SANCROX QUARRY EXPANSION (SSD 7293) – RESPONSE TO FURTHER REQUEST FOR INFORMATION (FLYROCK ASSESSMENT)

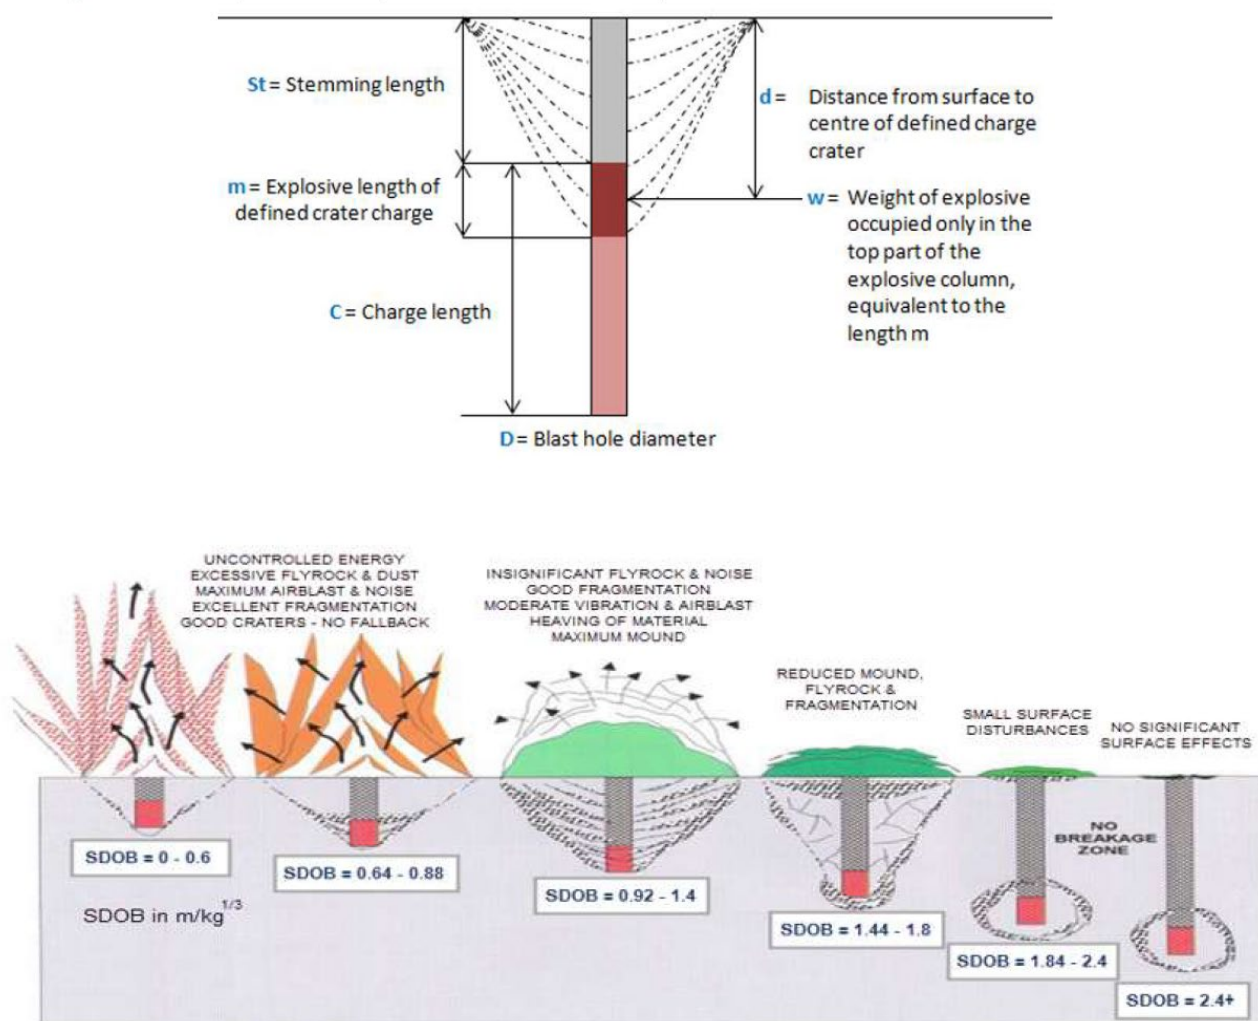
Issue raised: The Department requests an updated flyrock assessment for the project that includes predicted throw distances and proposed measures such as blast design, buffer zones and any other relevant measures to mitigate flyrock impacts.

The concept of Scaled Depth of Burial (SDOB) detailed in the exert below (**Figure 1**) demonstrates the relationship that SDOB has on influencing flyrock and the effects of SDOB on the bench surface with flyrock generation from cratering (page 4 - 5, Buffer Zone Assessment Report, Orica 2022). The SDOB was based on cratering experiments that found that flyrock is affected by the depth of burial or stemming length ('St'), and the length of explosives directly below the stemming as dictated by the charge length factor ('m'). The second part of Figure 1

shows the expected surface expression of a range of SDOB. SDOB of 0.92 – 1.4 is typically targeted for blast fragmentation.
